Wisconsin Department of Transportation

Proposal #21: 9670-16-71, WISC2026053
Marinette - Wausaukee
STH 64 – USH 141
STH 180
Marinette County

This is Addendum No. 01, which provides for the following:

Addendum No. 01
ID 9670-16-71
Revised Sheet 16
November 3, 2025

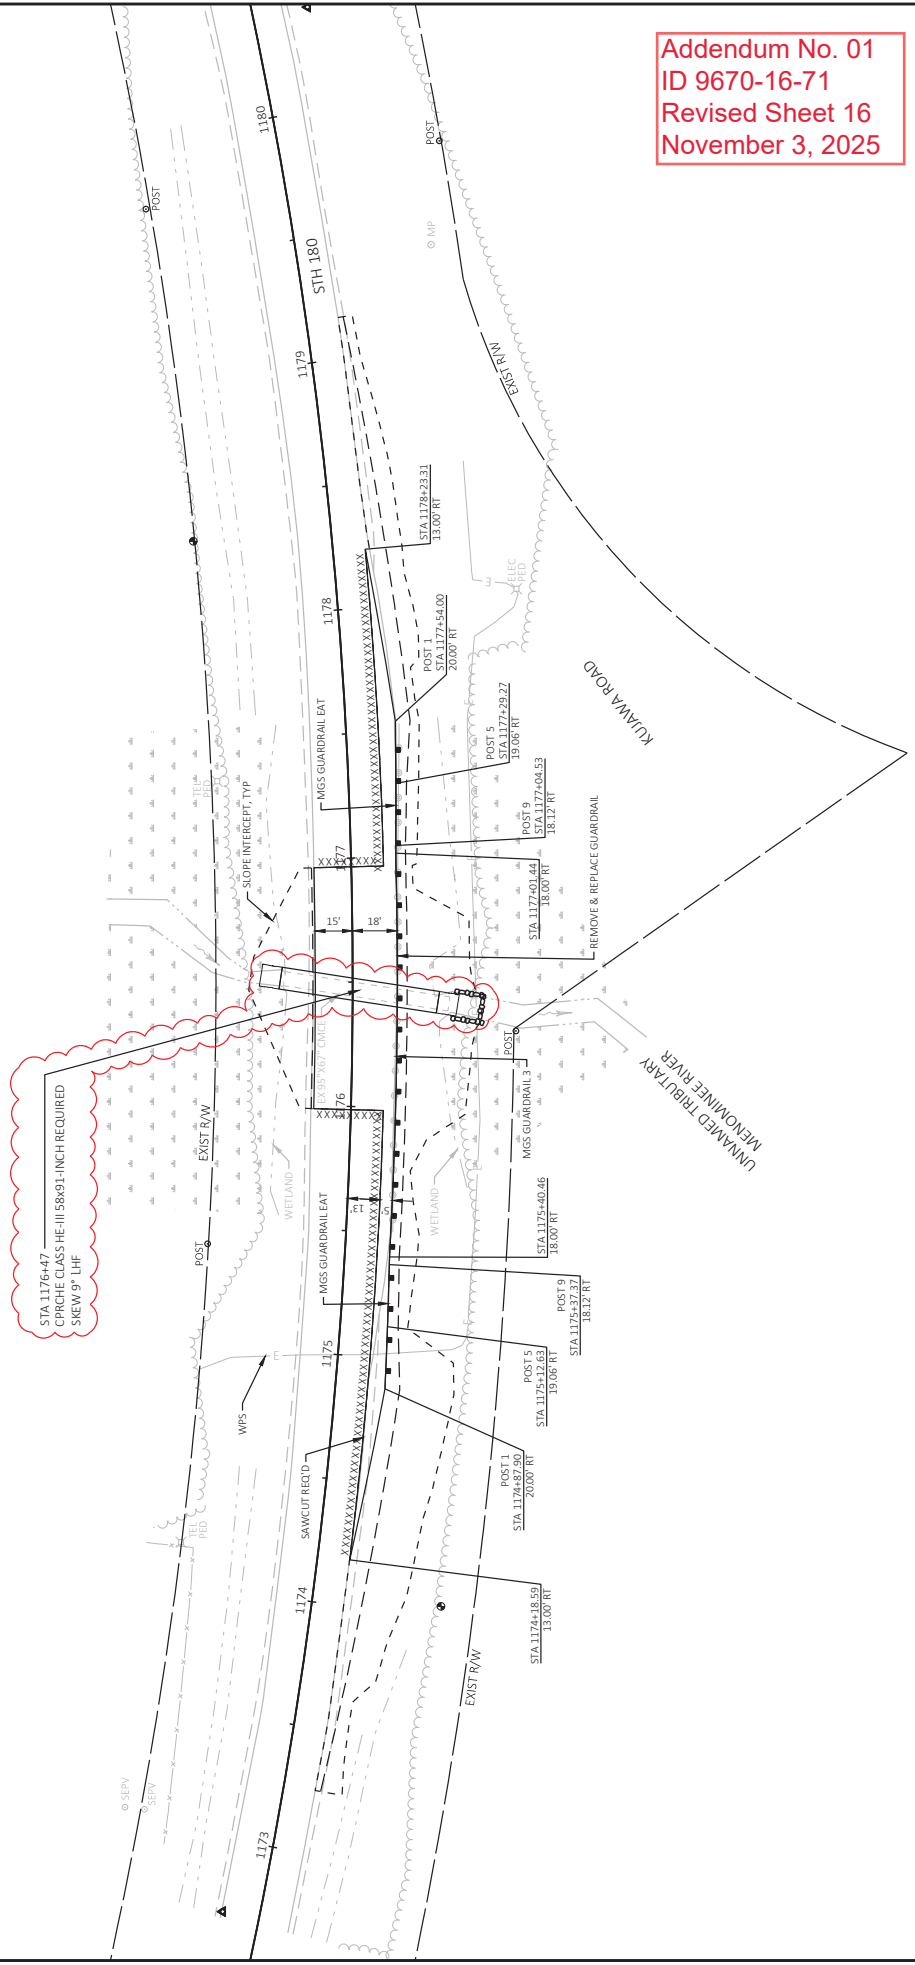
Revised Plan Sheets	
Plan Sheet	Plan Sheet Title (brief description of changes to sheet)
9	Construction Details (Revised approximate depth to top of pipe at Station 1176+47)
16	Construction Details – MGS Guardrail (Revised pipe size and length at Station 1176+47)
19	Erosion Control Plan (Revised pipe length at Station 619+72)
22	Erosion Control Plan (Revised pipe size and length at Station 1176+47)
42	Miscellaneous Quantities (Revised pipe size at Station 1176+47 under Cofferdams)
45	Miscellaneous Quantities (Revised apron endwall sizes at Station 1176+47)
46	Miscellaneous Quantities (Revised pipe length at Station 619+72 and pipe size and length at Station 1176+47)
74	Plan and Profile: Culvert #38180016278 (Revised pipe length at Station 619+72)
92	Plan and Profile: C-38-116 (Revised pipe size and length at Station 1176+47)
181	Cross Sections: STH 180 (Revised pipe length at Station 619+72)
190	Cross Sections: STH 180 (Revised pipe size and length at Station 1176+47)

STA 1176+47
CPRCHE CLASS HE-III 58x91-INCH REQUIRED
SKEW 9° L/HF
